ADA Curb Ramp New Construction Inspection Form (Parallel)

309th	24952.54			Yorkshire
North-South Road Name	Project No.	Sheet No.	Intersection No.	East-West Road Name

PARALLEL RAMP (PL)

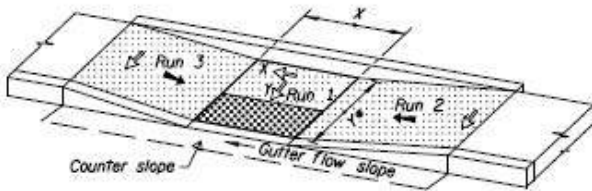
Det. warning full width of ramp	<input type="text" value="N"/> Y <input type="checkbox"/> N <input checked="" type="checkbox"/>

RAMP RUN 2	Pass	Fail
Running Slope 2	<input type="text" value="8.6"/> $\leq 8.3\%$ <input type="checkbox"/> $> 8.3\%$ <input checked="" type="checkbox"/>	
Length 2	<input type="text" value=""/>	
Cross Slope 2	<input type="text" value="1.4"/> $\leq 2.0\%$ <input checked="" type="checkbox"/> $> 2.0\%$ <input type="checkbox"/>

RAMP RUN 3	Pass	Fail
Running Slope 3	<input type="text" value="20.8"/> $\leq 8.3\%$ <input type="checkbox"/> $> 8.3\%$ <input checked="" type="checkbox"/>	
Length 3	<input type="text" value=""/>	
Cross Slope 3	<input type="text" value=""/> $\leq 2.0\%$ <input type="checkbox"/> $> 2.0\%$ <input type="checkbox"/>

No td
